V-44 (2012)

Plan
5-24-12

TYPE OF VARIANCE: Waive the required 50 foot undisturbed buffer adjacent to a cemetery to 22 feet.

Application for Variance

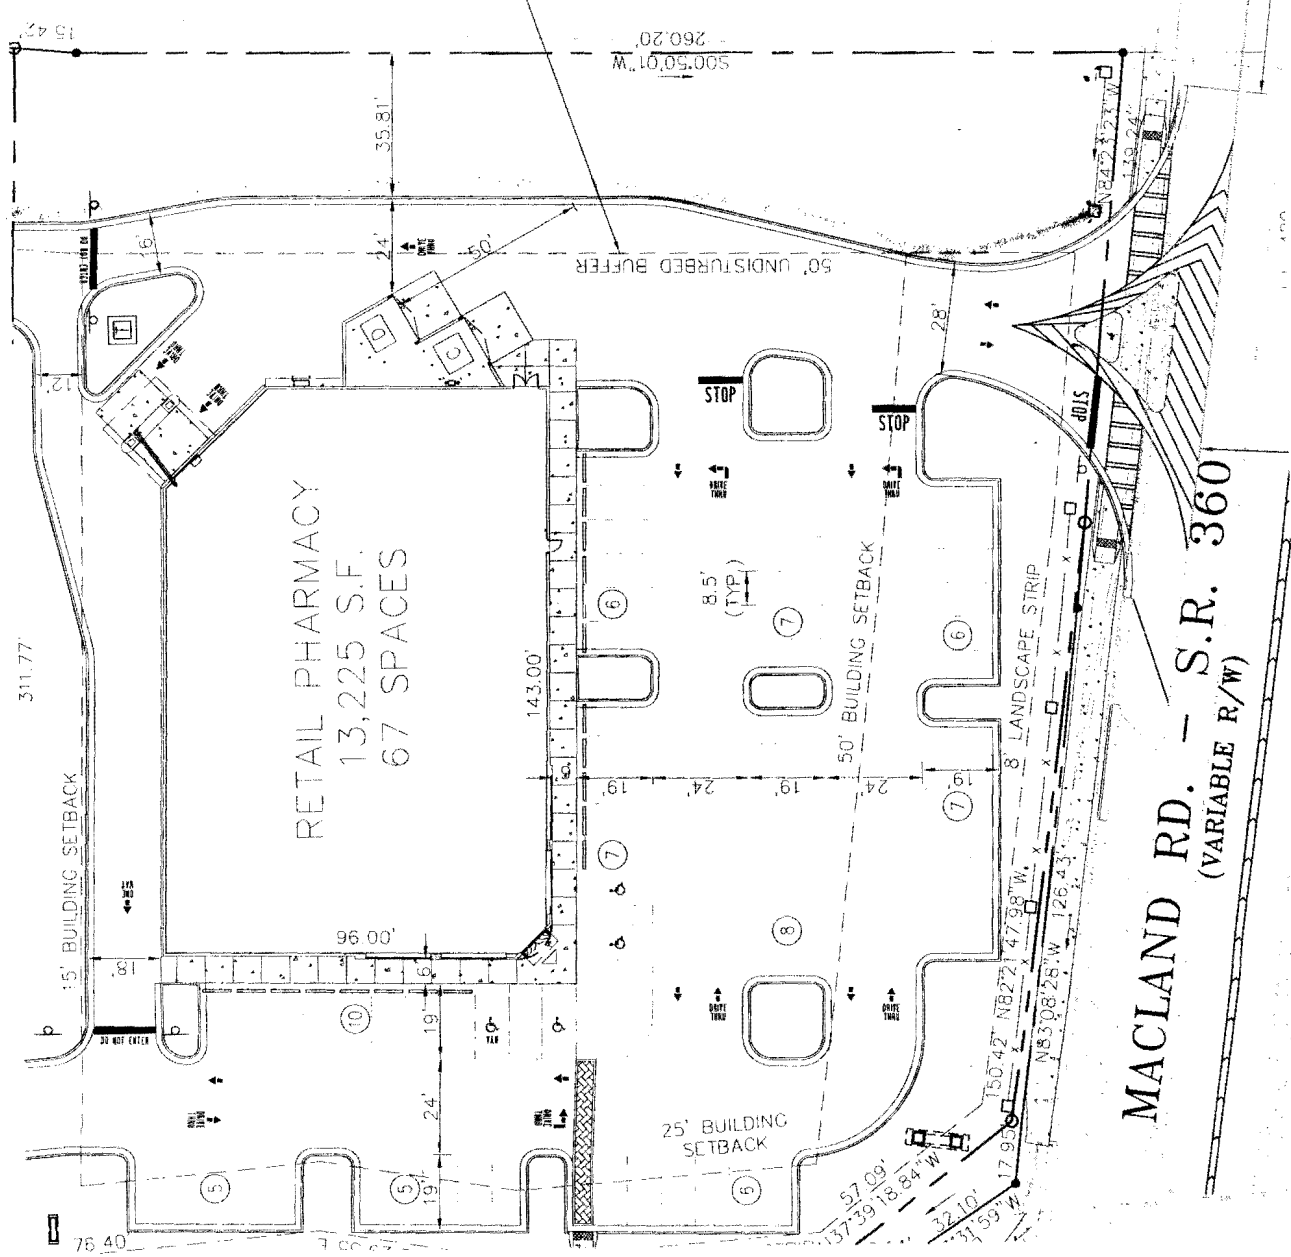
TRAFFIC: Recommend GDOT permits for all work that encroaches upon State right-of-way. Recommend applicant coordinate with Georgia DOT prior to development plan approval to ensure compatibility with the SR360/Macland Road project, PI 0006049.

STORMWATER MANAGEMENT: The undisturbed buffer encroachment should to the plan provided and all detention and stormwater management must be located outside the buffer.

A. Provide and install an orange protective fence on the outer perimeter of the maintained natural buffer as detailed on the plan submitted May 24, 2012 before beginning construction. The protective fence to be maintained in good repair throughout the development phase of the project. At completion of the project, the orange protective fence shall be removed from the premises.

C. Provide and install a permanent six (6) foot chain link fence outside the maintained natural buffer as detailed on the plan submitted May 24, 2012. Fence must be 9 gauge with top and bottom rails and fence posts must be set in concrete. Fence to be black vinyl coated chain link.
